**AGENDA**  
**PLANNING & ZONING COMMISSION SPECIAL MEETING**  
**TUESDAY, JULY 26, 2022 - 3:30 PM**  
**McAllen Development Center, 311 N. 15<sup>th</sup> Street, McAllen, Texas**  
**EXECUTIVE CONFERENCE ROOM, PLANNING DEPARTMENT**

**Memo**

**TO:** Planning and Zoning Commission  
**FROM:** Planning Staff  
**DATE:** July 11, 2022  
**SUBJECT:** **SITE PLAN APPROVAL FOR LOT 10, CITRUS GROVE PLAZA PHASE 1-A, LOT 10. 4129 EXPRESSWAY 83. (SPR2022-0036)**

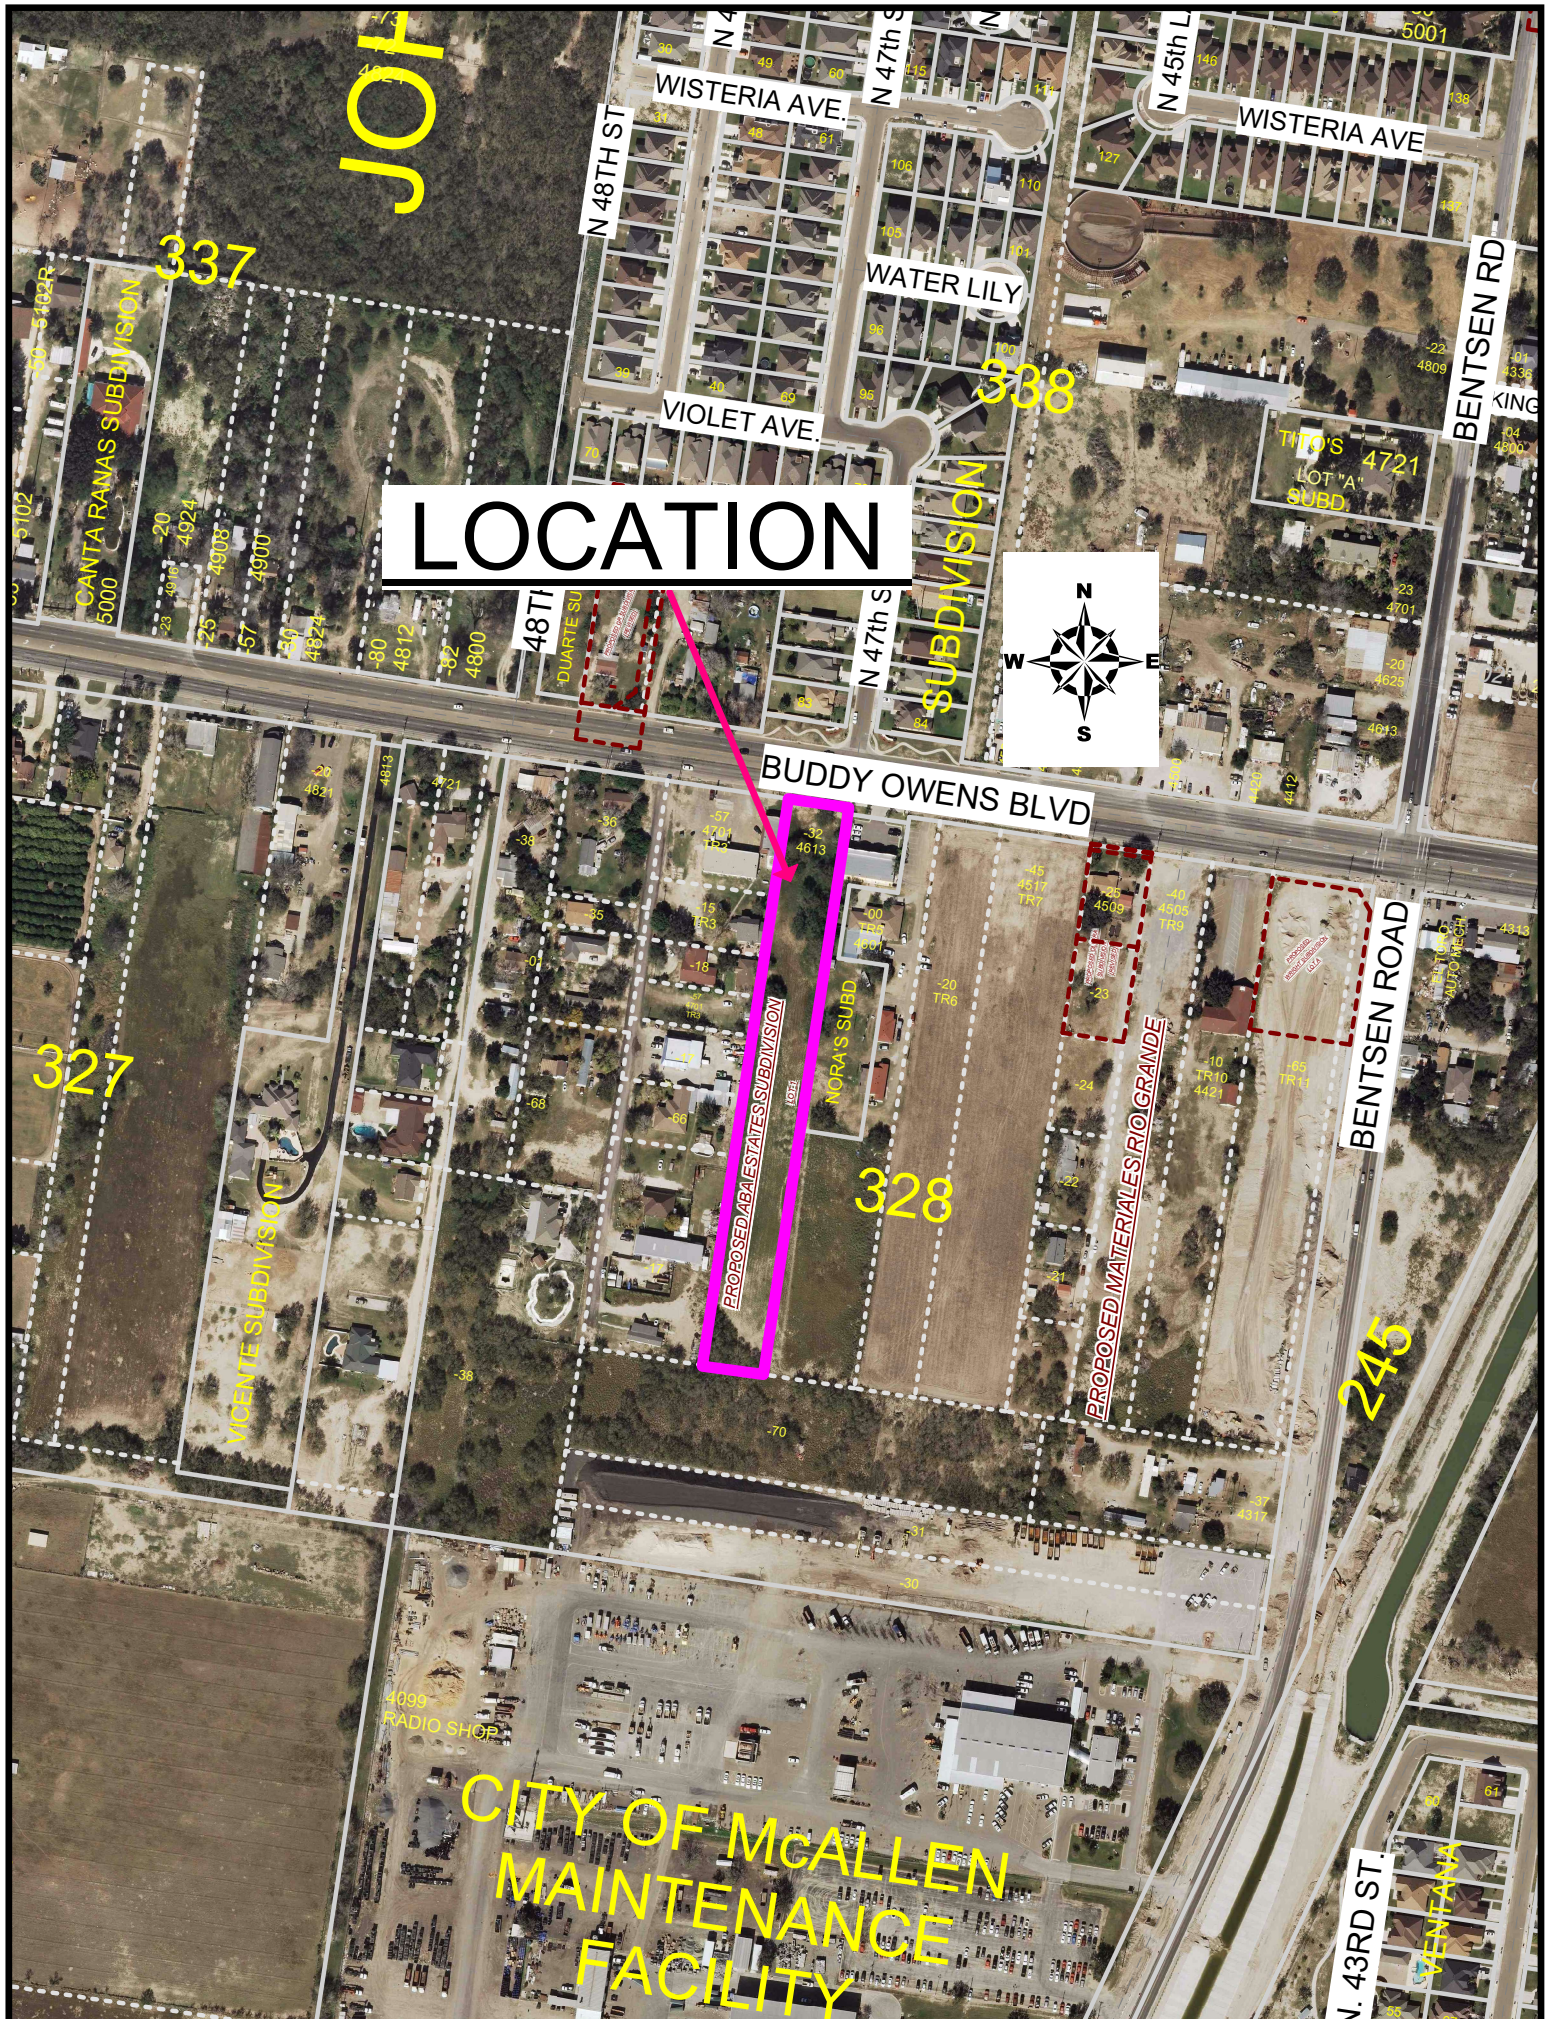
<b>SUBDIVISION NAME: ABA ESTATES</b>	
<b>REQUIREMENTS</b>	
<b>STREETS AND RIGHT-OF-WAYS</b>	
Buddy Owens Boulevard: 10 ft. of additional ROW dedication required for 60 ft. from centerline for 120 ft. total ROW Paving: By the state Curb & gutter: By the state **Subdivision Ordinance: Section 134-105 **Monies must be escrowed if improvements are required prior to final **COM Thoroughfare Plan	Applied
N.47th Street on west boundary: 25 ft. dedication from centerline for future 50 ft. ROW Paving: 32 ft. Curb & gutter: Both Sides *ROW being reviewed and plat would need to be revised accordingly. After review of ownership map submitted by engineer on July 07,2022 properties along western boundary provide 25 ft. access easement along west side, as properties to the west develop access easement will be reviewed for ROW dedication. **Subdivision Ordinance: Section 134-105 ***Monies must be escrowed if improvements are required prior to final ****COM Thoroughfare Plan	NA

* 600 ft. Maximum Cul-de-Sac **Subdivision Ordinance: Section 134-105	NA
<b>ALLEYS</b>	
ROW: 20 ft. Paving: 16 ft. ***Provide plat note as shown prior to recording, "A minimum 24 ft. private service drive easement will be established as part of the site plan and will be maintained by the lot owners and not the city of McAllen." *Alley/service drive easement required for commercial and multi-family properties. **Must comply with Public Works Alley/ service drive easement requirements. ***Alley/ service drive easement must comply with Fire Department requirements. ****Alley or service drive easement cannot dead-end. *****Subdivision Ordinance: Section 134-106	Required

<b>SETBACKS</b>	
<p>* Front: In accordance with zoning ordinance, or greater for easements or approved site plan, or in line with average setback, whichever is greater applies.                      **Revise note as shown above prior to recording.                      ***Proposing: 60 ft. or greater for approved site plan or easements.                      ****Clarify front setback prior to recording.                      *****Zoning Ordinance: Section 138-356</p>	Required
<p>* Rear: In accordance with Zoning Ordinance or greater for easements or approved site plan, whichever is greater applies.                      **Revise note as shown above prior to recording.                      ***Proposing: In accordance with Zoning Ordinance or greater for easements or approved site plan.                      *****Zoning Ordinance: Section 138-356</p>	Required
<p>* Sides: In accordance with Zoning Ordinance or greater for easements or approved site plan, whichever is greater applies.                      **Revise note as shown above prior to recording.                      ***Proposing: In accordance with Zoning Ordinance or greater for easements or approved site plan.                      **Zoning Ordinance: Section 138-356</p>	Required

<b>COMMENTS</b>	
Comments: *Must comply with City's Access Management Policy. ** Submit ownership map with surrounding legal descriptions and document numbers, to ensure no landlocked properties exist or will be created. After review of ownership map submitted by engineer on July 07,2022 properties along western boundary provide 25 ft. access easement along west side, as properties to the west develop access easement will be reviewed for ROW dedication. ***Please submit updated survey that corresponds to the proposed subdivision	Applied
<b>RECOMMENDATION</b>	
Recommendation: STAFF RECOMMENDS APPROVAL OF THE SUBDIVISION IN FINAL FORM SUBJECT TO CONDITIONS NOTED.	Applied

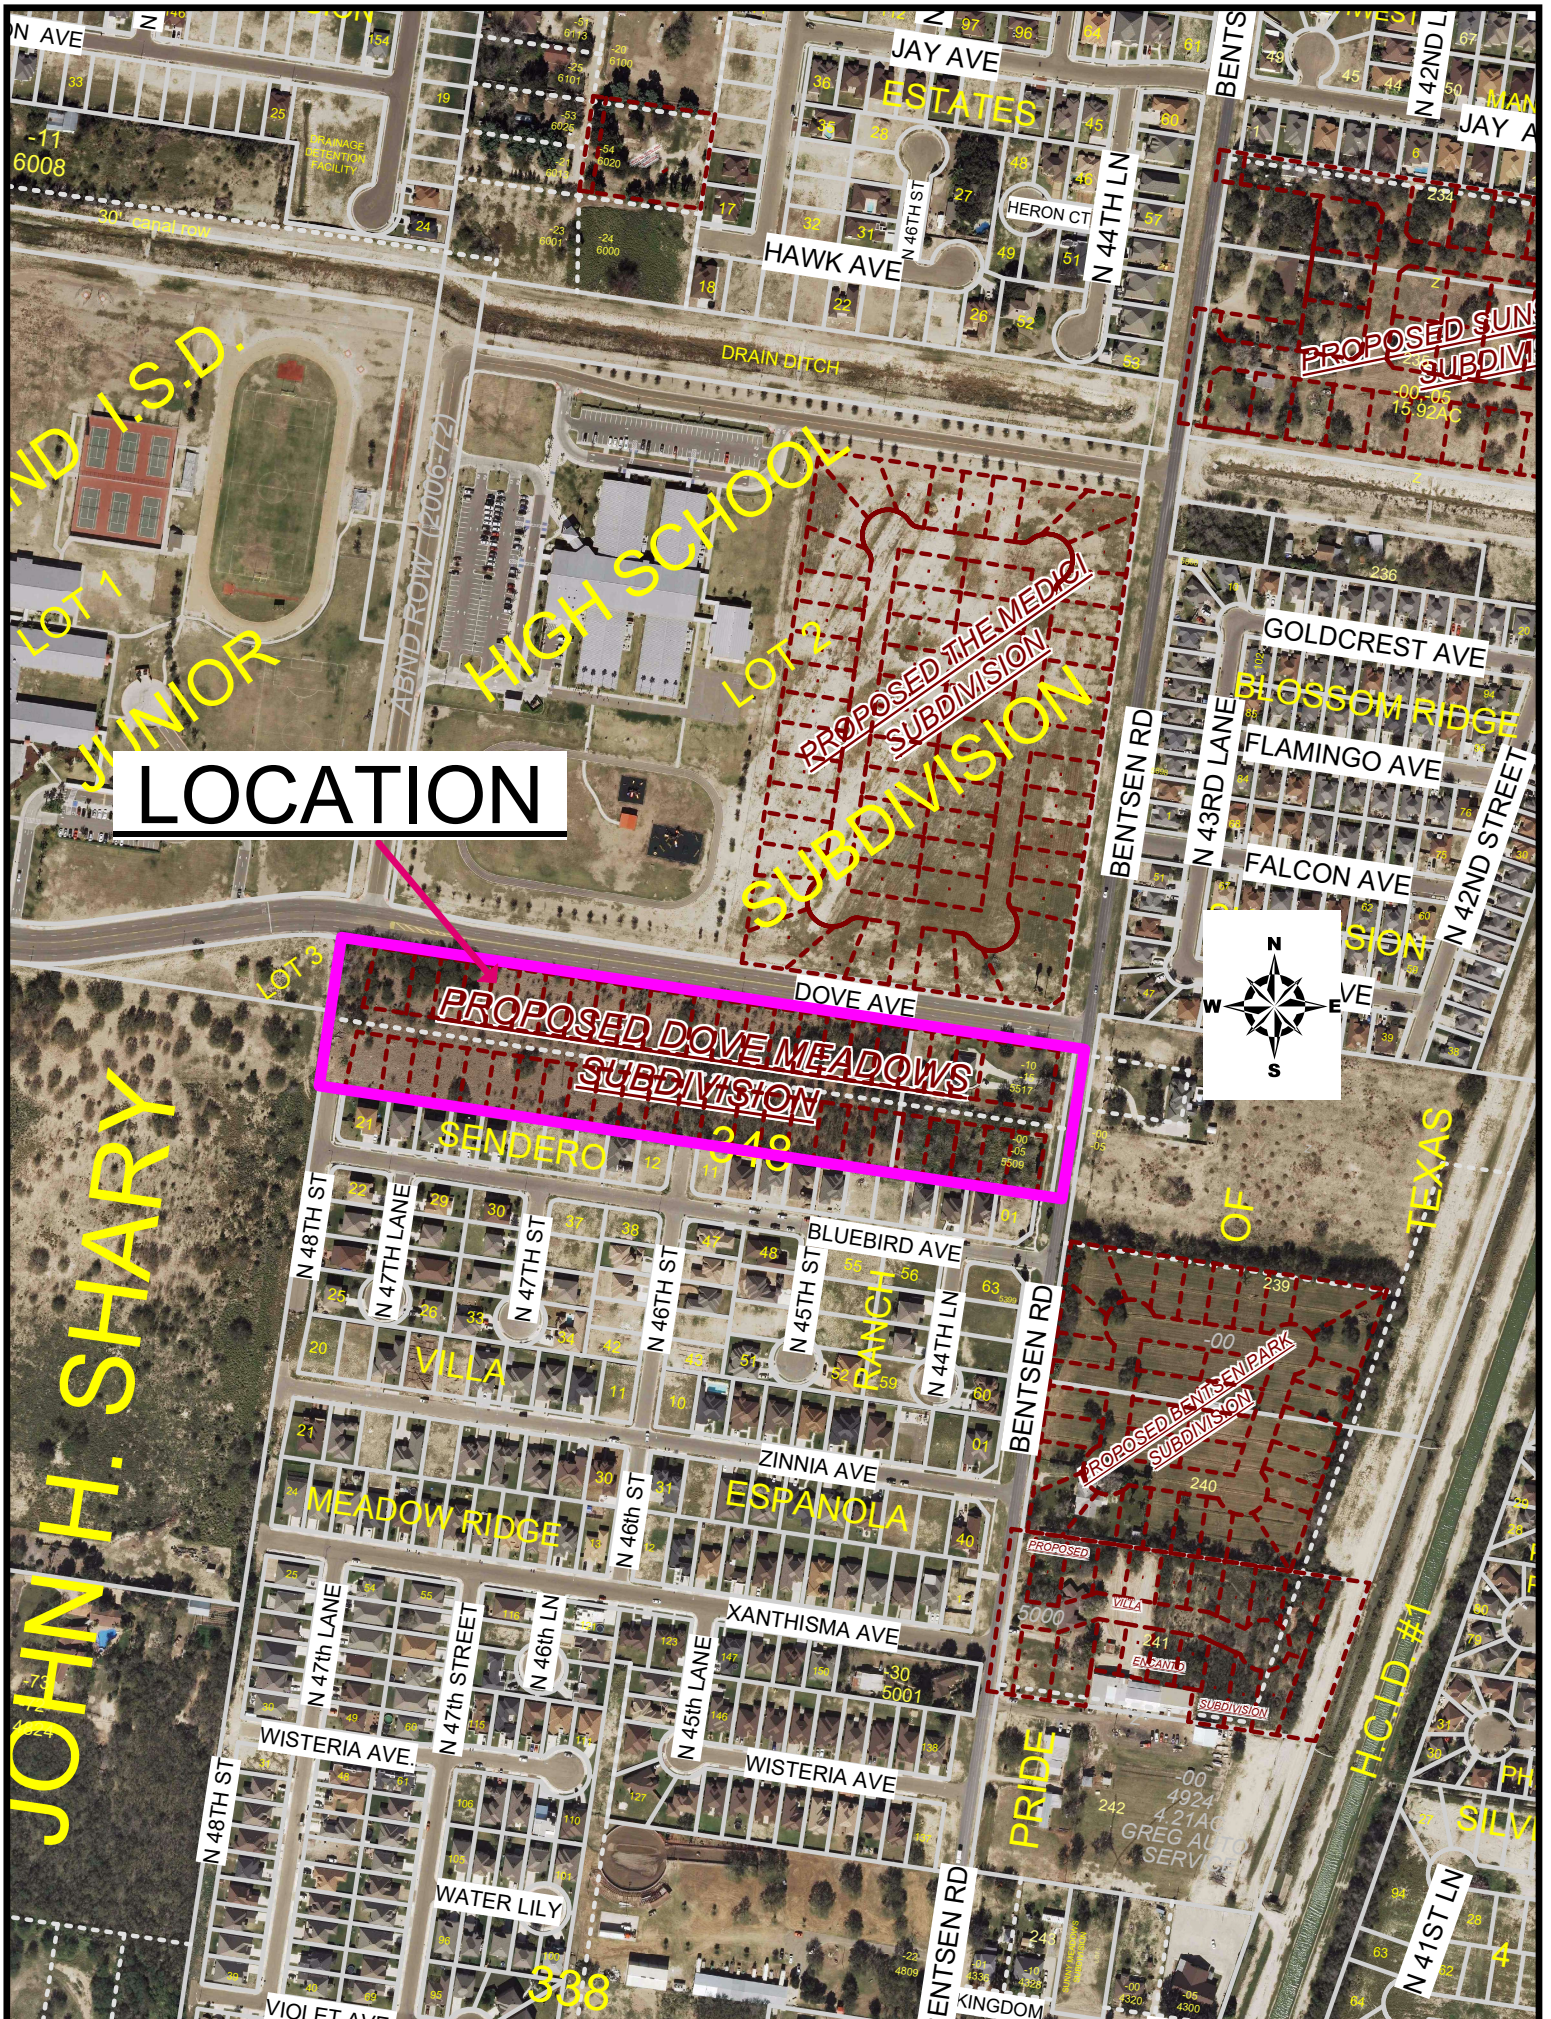
<b>SUBDIVISION NAME: DOVE MEADOWS</b>	
<b>REQUIREMENTS</b>	
<b>STREETS AND RIGHT-OF-WAYS</b>	
<p>N. Bentsen Road: Dedication as needed for 100 ft. total ROW.                      Paving: 65 ft. Curb &amp; gutter: both sides                      *Label centerline along N. Bentsen Road., prior to final.                      **Label ROW dedications from centerline to new plat boundary, total, existing, etc., prior to final.                      ***Provide Document Numbers on plat for existing ROW dedication and Documents, prior to final.                      ****Staff is reviewing street alignment with the subdivisions to the north and south, ROW requirements are subject to change to match existing ROW and paving widths, finalize prior to final.                      *****Finalize ROW requirements prior to final.                      *****Subdivision Ordinance: Section 134-105                      *****Monies must be escrowed if improvements are required prior to final                      *****COM Thoroughfare Plan</p>	Non-compliance

<p>Dove Avenue: Dedication as needed for 75 ft. from centerline for 150 ft. total ROW.                      Paving; 65 ft. min. Curb &amp; gutter. both sides                      *Subdivision as proposed at this time shows only an additional 10 ft. ROW., finalize ROW requirements prior to final.                      **If proposing less ROW than required a Variance Request will be required.                      ****Label centerline along Dove Avenue., prior to final.                      *****Provide Document Numbers on plat for existing ROW dedication and Documents, prior to final.                      *****Label ROW dedications from centerline to new plat boundary, total, existing, etc., prior to final.                      *****Subdivision Ordinance: Section 134-105                      *****Monies must be escrowed if improvements are required prior to final                      *****COM Thoroughfare Plan</p>	Non-compliance

<p>N. 46th Street: Proposing 50 ft. total ROW.                      Paving: 32 ft. Curb &amp; gutter: Both Sides                      **Verify street alignment with the subdivision the south, as ROW requirements are subject to change to match existing ROW and paving widths, finalize prior to final.                      ***Subdivision Ordinance: Section 134-105                      ****Monies must be escrowed if improvements are required prior to final                      *****COM Thoroughfare Plan</p>	Applied

<p>* Rezoning Needed Before Final Approval                  **A portion of proposed subdivision currently be rezoned from C-2(Neighborhood Commercial) District to R-1(Single-Family Residential) District, and is scheduled for the Planning and Zoning Commission meeting of August 2,2022 and City Commission meeting of August 22,2022.                  ***Zoning Ordinance: Article V</p>	<p>Required</p>
<p><b>PARKS</b></p>	
<p>* Land dedication in lieu of fee.                  * Park Fee of \$700 per lot/dwelling unit to be paid prior to recording. As per Park Department fees apply to this subdivision at a rate of \$700 per dwelling unit, this in accordance with McAllen’s Park Land Dedication and Park Development Fees Ordinance. Amount comes to \$31,500, based on \$700 for each individual home and payable prior to plat recording. Fees can go up or down, they are dependent on the number of units.                  * Pending review by City Manager's Office.</p>	<p>TBD</p>

<p>Required</p>
	<p>TBD</p>
<p><b>TRAFFIC</b></p>	
<p>* As per Traffic Department, Trip generation for 45 lot single family is approved and no TIA is required.                  * Traffic Impact Analysis (TIA) required prior to final plat.                  *** As per Traffic Department, Trip generation for 45 lot single family is approved and no TIA is required.</p>	<p>Completed</p>
	<p>NA</p>
<p><b>COMMENTS</b></p>	
<p>Comments:                  *Verify street alignment with the subdivision the south, as ROW requirements are subject to change to match existing ROW and paving widths, finalize prior to final.                  **Must comply with City’s Access Management Policy.</p>	<p>Applied</p>
<p><b>RECOMMENDATION</b></p>	
<p>Recommendation: STAFF RECOMMENDS APPROVAL OF THE SUBDIVISION IN PRELIMINARY FORM SUBJECT TO CONDITIONS NOTED, UTILITIES AND DRAINAGE APPROVALS.</p>	<p>Applied</p>
